CITY OF CHARLES TOWN
HISTORIC LANDMARKS COMMISSION
AGENDA • DECEMBER 9, 2024

Certificate of Appropriateness
COA-2024-19

Certificate of Appropriateness
COA 2024-20

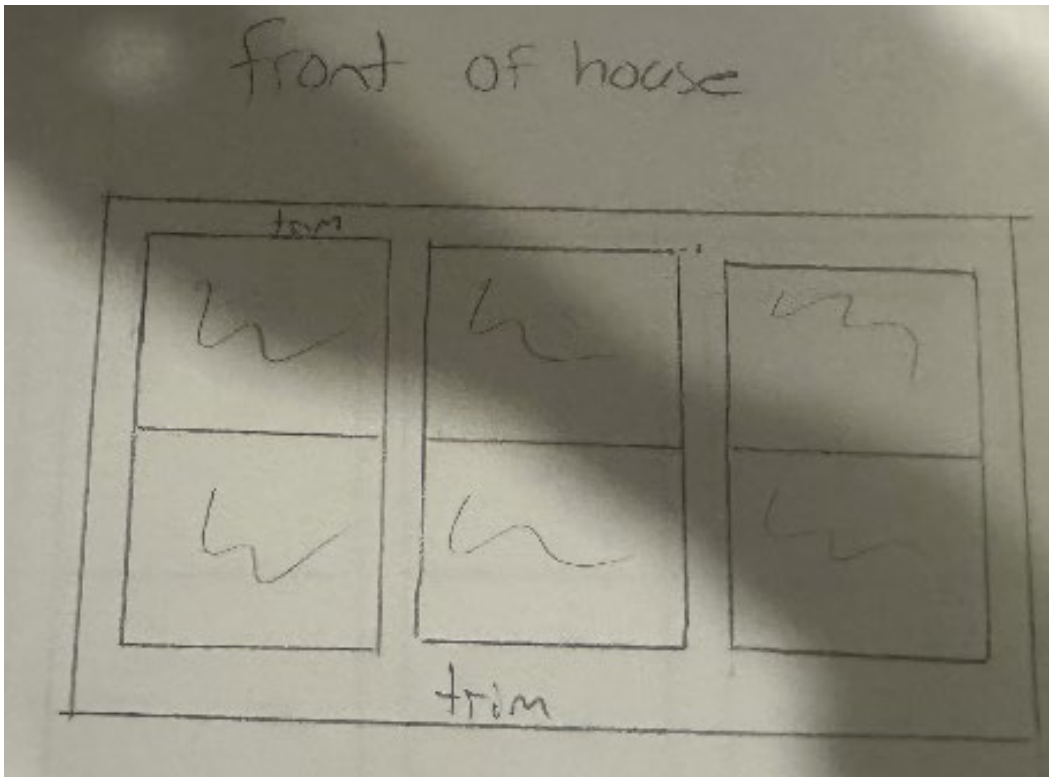
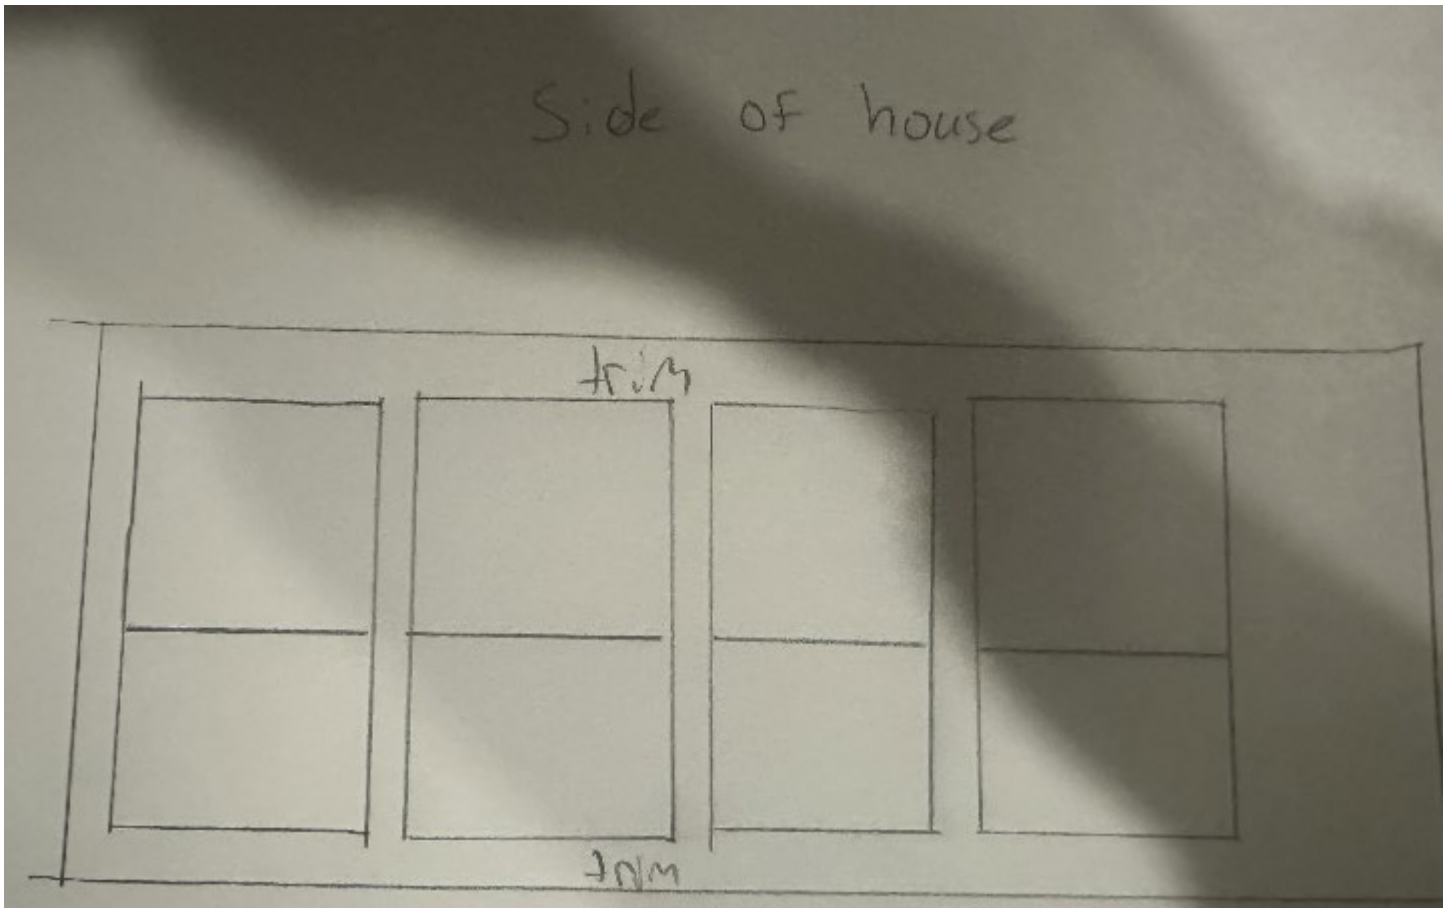
The home owner has removed the colonial window grid sets that were located on the second floor corners and replaced them with single windows without Historic Landmarks Commission approval. The windows were removed sometime between 2021 and 2024.

The building seems to have been heavily modified since it's induction into the Historic Overlay. It no longer has the appearance of "*a modest residence from the late 19th century*". The windows which were illegally removed were one of the few remaining historical facets of the structure.

The proposed replacement window type is a wooden double hung design. The application will arrange them in rows to recreate the style the house previously had.

Approval, subject to conditions:

1. Six windows shall be installed on the second floor in parallel in the rear of the house,
2. Two windows shall be installed on the second floor in parallel above the door facing S. Lawrence Street,
3. Six windows shall be installed on the second floor in parallel, in the overhang, facing S Lawrence Street.
4. Three windows shall be installed on the second floor in parallel, in the overhang, facing W. Congress Street.
5. Two windows shall be installed on the second floor facing W. Congress Street.
6. The windows shall be installed with the intent to mimic the look of the structure as seen in the June 2021 Streetview images available from Google.com, and which are seen in page two of this report.

Figure 5. Stone archway over the center, condemned, entryway. This archway cannot be seen from the street due to the current porch structure obscuring it. Reference Figure 1.

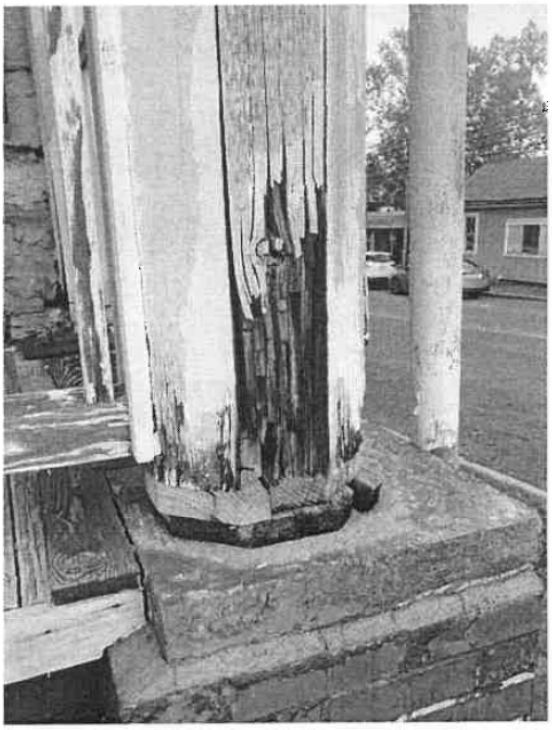
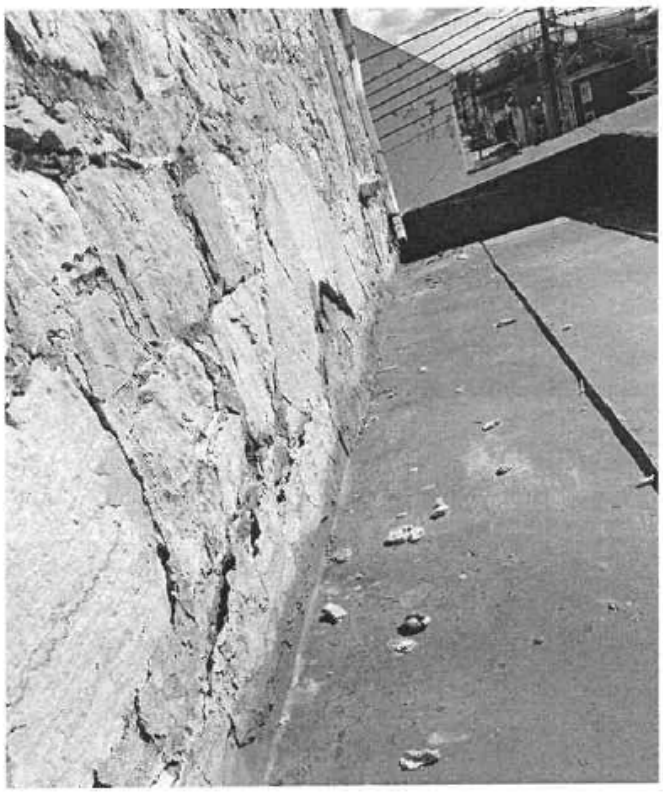
Applicant states that porch is at an imminent risk of collapse due to the deteriorated condition of the columns, which are wood and rotting. Water continues to infiltrate the columns, stonework, and basement, causing ongoing damage to the structure.

The applicant states that the porch is not an original part of the lecture hall, and that it's current design obscures important historical architectural details, such as the stone arch located in the center of the front façade.

The proposed demolition and rebuild is consistent with the intent of the Design Guidelines to preserve historic structures by removing dangerous/out-of-character components and replacing them with safer/more historically accurate features.

Figure 7. Architectural sketch of the proposed porch.

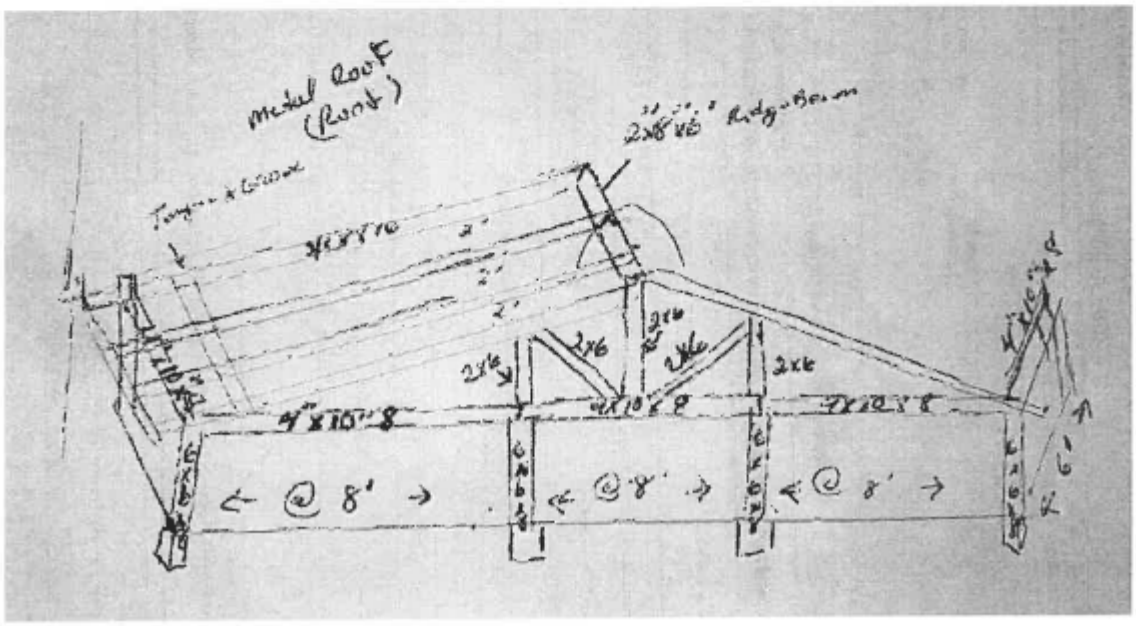
The applicant proposes to build a new porch after the current one is demolished. The proposed design is a gable roof with exposed truss and gable end. This will allow the currently hidden stone arch to be visible.

The porch will have a wooden floor, 6x6 wooden columns, wooden beams and rafters, and wooden ceiling set in a tongue and groove fashion. The roof will contain snow guards and a new gutter system to direct water to the street corner away from the structure.

The new porch has an emphasis on wood, vertical design emphasis (the columns and structural supports), and a pointed 'arch way' at the roof center, while bring back to visibility the original stone archway.

Approval.
